## **ADDENDUM NO. 1**

Item No. 4A – Remark Runway Thresholds 4/22, 14R/32L & 18/36.

U of I – Willard Airport

IL Project No.: CMI-3662

REMARK RUNWAY THRESHOLDS  
REMOVAL AND REPLACEMENT PLAN  
RUNWAY 4 / 22

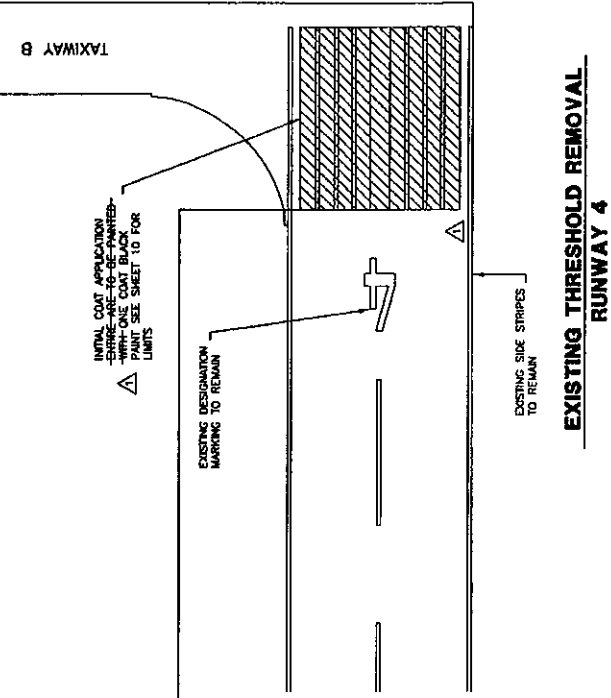
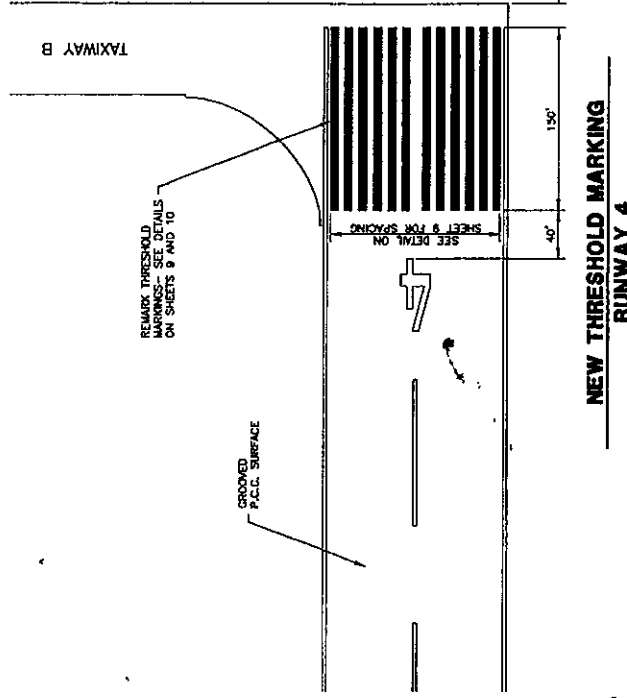
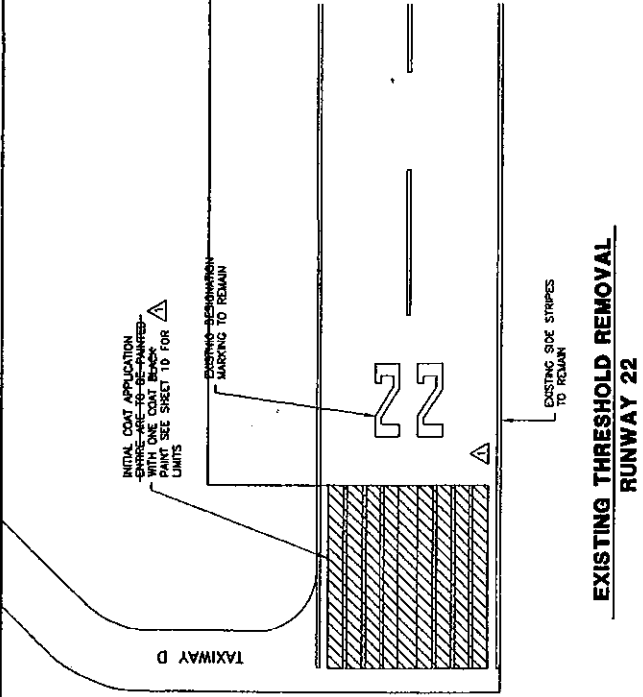
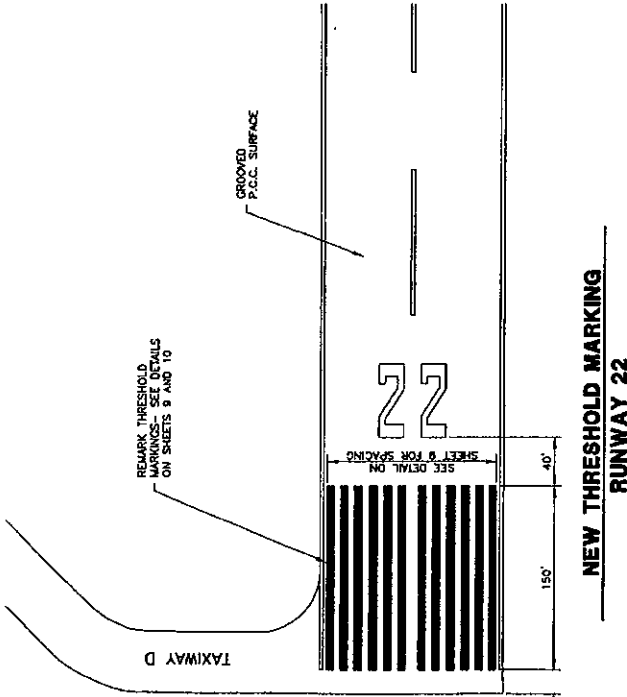
Revise marking plan and Schedule of Prices.

- The limits and quantity of Initial Coat Application has been reduced from 117,900 SF to 62,100 SF.
- The limits and quantity of Top Coat Application has been reduced from 125,934 SF to 116,421 SF.

The revisions are noted as Revision 1 on Sheets 1, 6, 7, 8, 9 and 10. Replace plan sheets 1, 6, 7, 8, 9 and 10.
